## **16047 Brunswick Quay Design Response Comments - 17.05.19**

### **Responses to Urban Design comments**

(Indicative images of metal railing fence below)

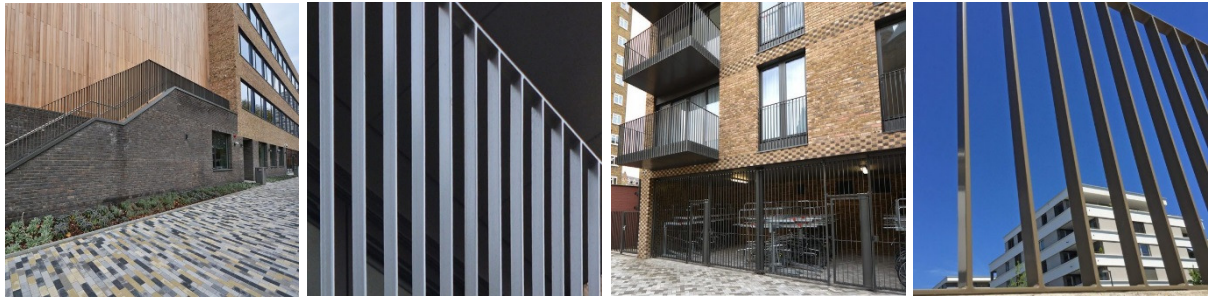
3. *"Further details are required detailing the boundary treatment of the car parks at the points where they front onto the surrounding public space to the north, east and west. They present a considerable frontage at ground and upper ground floor level and therefore they will have a significant role to play in forming the public realm."*

3. "Impact on the character and appearance of the docks"  
*"Of more concern is the 3m high vertical timber fence (labelled as B2 on the General Arrangements PDF). This would be installed between the proposed buildings all along the boundary with the dock. This feature is not shown on the visualisation and we have concerns about the stark appearance of this and especially in terms of the environment this would create along the 'dockside boulevard'. This fence and its height should be **amended**, possibly providing railings and/or softening with planting/climbers."*

A metal railing fence will provide a good combination of permeability across the site, and security between the buildings. The dark finish will compliment the dark brick plinths and architectural metalwork, whilst a climb planted base will infuse greenery to the public realm. Details for the new proposed fence are as follows:

- Vertical Metal Railings with climbing planting at base.
- Product: Lang + Fulton Rimini Flat Bar Railing, or similar & approved.
- Materials: Powder coated steel / Size: 2.4m height.
- Colour/finish: To match architectural metalwork

Details for the new proposed fence are as follows:

- Vertical Metal Railings with climbing planting at base.
- Product: Lang + Fulton Rimini Flat Bar Railing, or similar & approved.
- Materials: Powder coated steel / Size: 2.4m height.
- Colour/finish: To match architectural metalwork
